REMARKS/ARGUMENTS

Ser. No. 10/048,205
Amdt. dated October 23, 2003
Reply to Office action of April 23, 2003

Appl. No. 10/048,205
Amdt. Dated Oct. 23, 2003
Reply to Office action of Apr. 23, 2003
Annotated Sheet Showing Changes

FIG. 1

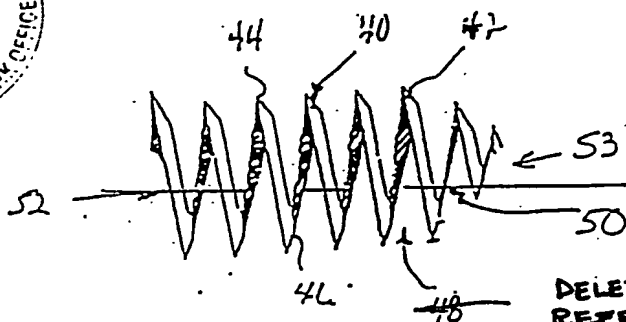
Regarding reference numerals shown in the drawings that are not present in the specification, element 48 has been deleted from FIG. 1 and element 94 has been

DELETE
REFERENCE
NUMERAL 48

FIG. 8B

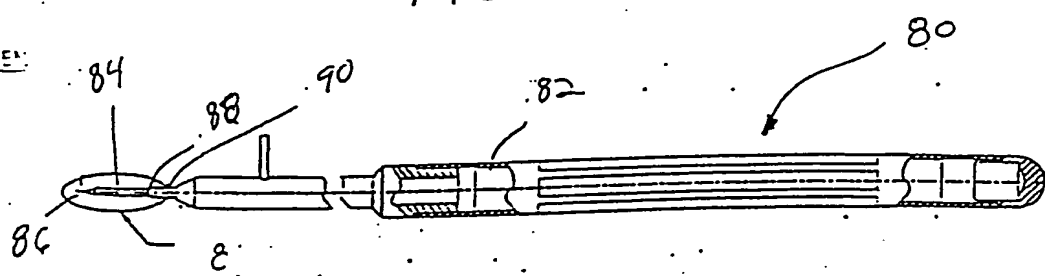
deleted from FIG. 8B. Replacement drawing sheets are provided along with annotated sheets explaining the changes made in the drawings. Regarding the omission of elements 52 and 53 from the specification, an amendment has been made at page 5, line 31 to insert a reference to the proximal and distal portions of the implant 52 and 53, respectively. Support for the inserted language defining proximal and distal portions is found at page 3, lines 3-4 of the application.

DELETE
REFERENCE
NUMERAL 94
